**Environmental  
Protection Agency**

July 19, 2011

RE: LORAIN COUNTY  
CITY OF AVON  
FRENCH CREEK RECREATIONAL AREA  
NPDES PERMIT NO. OHC000003  
OHIO EPA PERMIT NO. 3GC03950\*AG  
CONSTRUCTION STORM WATER

Figure 1. The outlet structure has not been modified for post construction as specified in the SWP3.

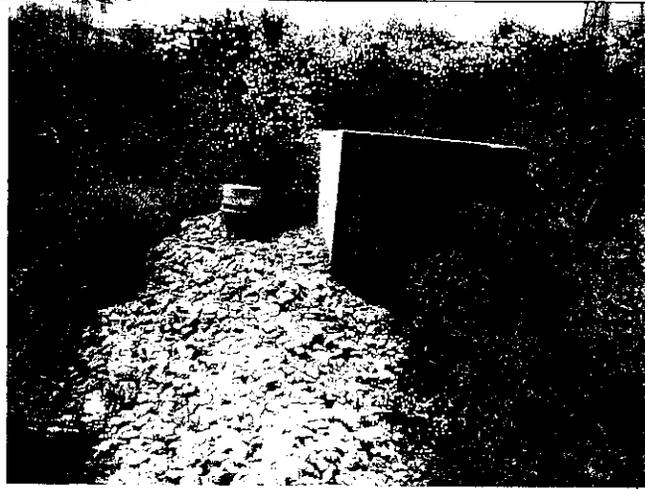
- The SWP3 indicates that the sediment basin will be converted into a wet extended detention pond once construction of the baseball stadium and recreation center is completed (see Sheet 45 of 67 of the construction drawings). The baseball stadium and recreation center have been completed for approximately 2 years, yet the basin is still configured per the sediment basin detail on Sheet 47 of 67 of the construction drawings (see Figure 1). Please complete installation of the wet extended detention pond as intended on Sheet 45 of 67 in the construction drawings. It calls for the installation of a 4.5-inch orifice to control the discharge of the Water Quality Volume (WQv), horizontal perforated pipe and stone (see attached drawing from SWP3) (See Figure 1).

Please provide me with a letter of response indicating the actions you will take to address the deficiencies noted above. Your response must be received and corrective action completed by August 1, 2011. If corrective action cannot be completed by this date, your response should include the date by when corrections will be completed. **The Notice of Termination submitted for this project will not be considered valid until the sediment basin is converted to its post-construction configuration.** Should you have any questions regarding this matter, please contact me at your earliest convenience at (330) 963-1128.
